## Best of February 2023

The following are a dozen questions answered by the NFSA's Codes, Standards, and Public Fire Protection staff as part of the Expert of the Day (EOD) member assistance program during the month of February 2023. This information is being brought forward as the "Best of February 2023." If you have a question for the NFSA EOD submit your question online through the "My EOD" portal.

### Question #1 – Through vs Membrane Penetrations

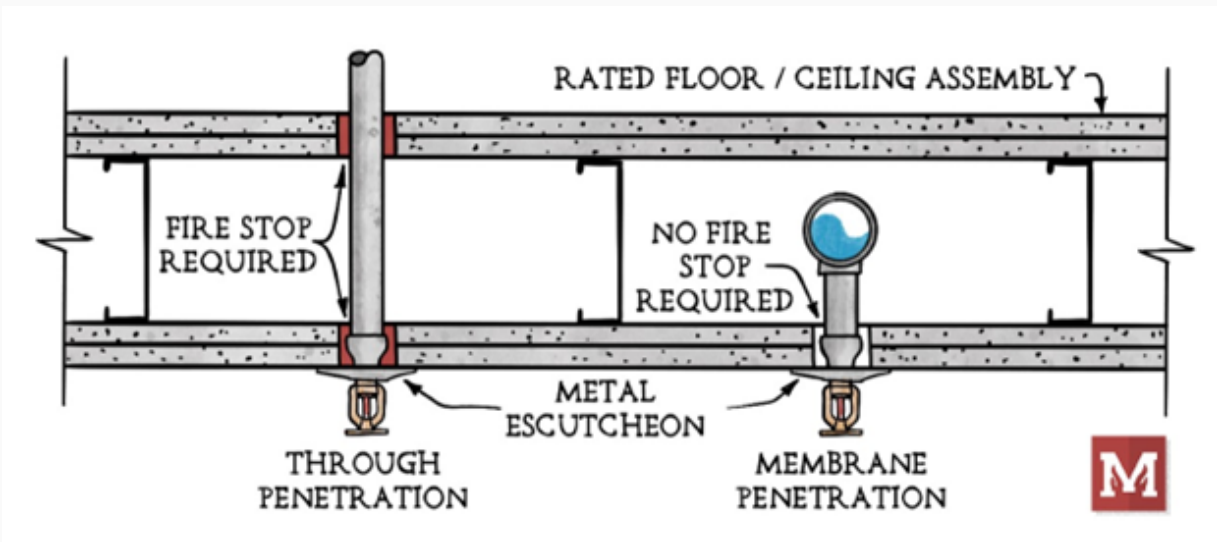
**A sprinkler drop is penetrating a two-hour rated ceiling assembly consisting of metal channel sandwiched between four layers of drywall.**

**Is it required to seal this penetration with fire stop material?**

The answer would depend upon if the penetration is considered a through penetration or a membrane penetration. The International Building Code (IBC), 2018 edition, Section 714.5 highlights the requirements for through penetrations vs. membrane penetrations as defined in Chapter 2 for horizontal assemblies such as a floor ceiling assembly.

A membrane penetration is a breach in one side of the floor-ceiling assembly and a through penetration is a breach in both sides of the floor ceiling assembly. For horizontal assemblies (floor/ceiling):

- Membrane penetrations: Section 714.5.2 provides the requirements for membrane penetrations and exception 5 allows for the annular space created by the penetration of a fire sprinkler with a metal escutcheon with no fire stopping required.

- Through penetrations: Section 714.5.1 provides the requirements for through penetrations and requires fire stopping.

## **Question #12 – Concealed Space with Composite Wood Joists**

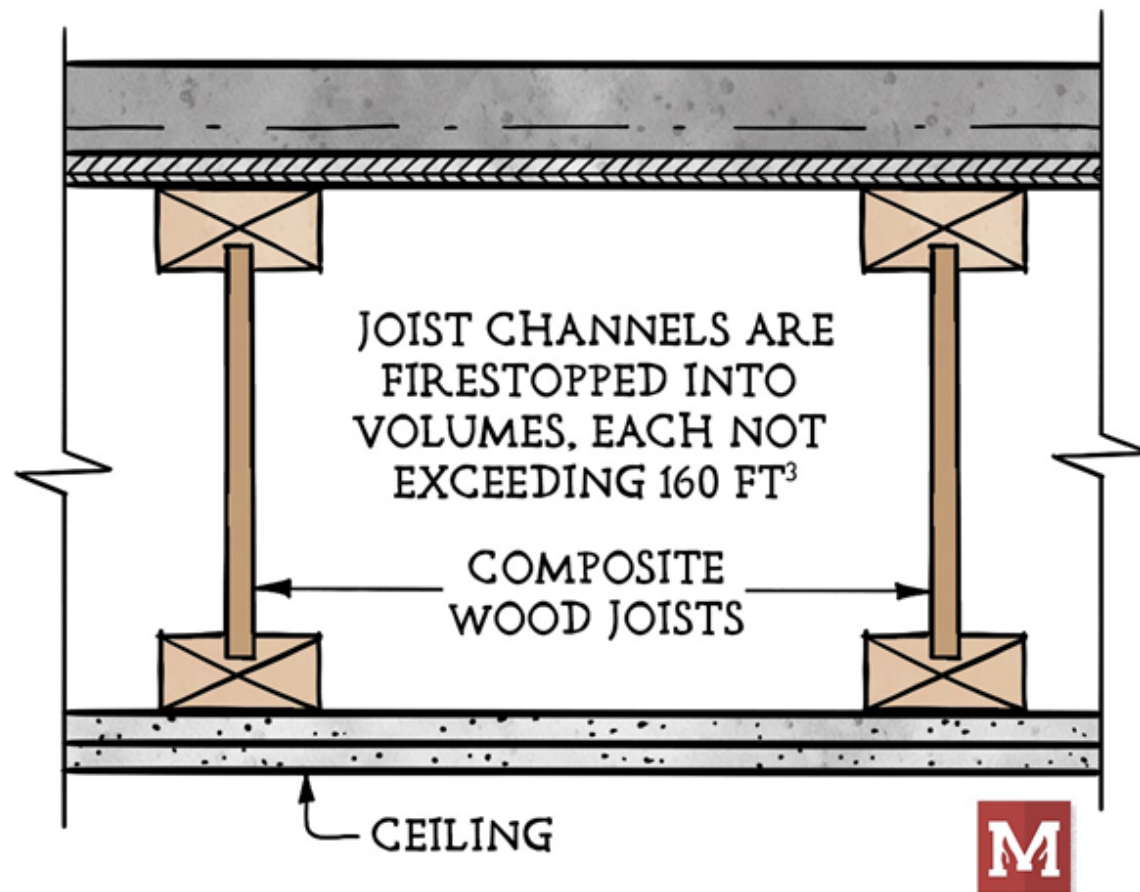
**The 2016 edition of NFPA 13 in Section 8.15.1.2.6 allows sprinklers to be omitted from concealed spaces consisting of composite wood joists with a gypsum board ceiling directly attached as long as the joist channels are fire stopped into 160 cubic foot volumes.**

**Is the firestopping mentioned required to be installed perpendicular to the composite wood joists or are the composite wood joists required to be encompassed or “sheathed” in order to omit sprinklers?**

In order to omit sprinkler protection in accordance with Section 8.15.1.2.6, the joist channels need to be fire stopped with materials equivalent to the web construction of the composite wood joist. This means the material would be installed perpendicular to the joist to limit fire spread through the joist channel. In order to apply this section, there is no need to sheath the entire composite wood joist. This is made clear by the requirement to use a “material equivalent to the web construction.

Also note that if the ceiling is installed using metal channels (1 inch max), 3 ½ inch batt insulation needs to be installed at the bottom of the joist panels.

As stated, the requirements of 8.15.1.2.6 are only specific to whether sprinklers can be omitted from a combustibile concealed space. Section 11.2.3.1.5 must also be considered. This section requires the adjacent area of sprinkler operation to be 3,000 square feet unless one of the exceptions found in 11.2.3.1.5.2 are met.

Section 11.2.3.1.5 has nothing to do with sprinklers being permitted to be omitted but rather to compensate for a potentially larger fire that may originate in an unprotected space. If a fire is not contained in the unprotected space, a larger design area is mandated to compensate for the larger fire when it does break through to a sprinklered area.

In order to avoid increasing the design area, the conditions are more stringent. Section 11.2.3.1.5.2(10) is specific that the composite wood joist construction is specific that “adjacent joist channels” need to be fire stopped into volumes not exceeding 160 cubic feet using materials equivalent to 1/2 inch gypsum board.

This differs then the requirements of 8.15.1.2.6 in two ways:

1. 8.15.1.2.6 requires the firestop materials to be equivalent to the web construction while 11.2.3.1.5.2(10) requires the firestop materials to be equivalent to 1/2 inch gypsum board.

2. 8.15.1.2.6 requires each individual joist channels to be fire stopped into volumns of 160 cubic feet while 11.2.3.1.5.2(10) requires “adjacent joist channels” to be fire stopped into 160 cubic feet volumes which may require the fire stopping to be installed between joist channels.
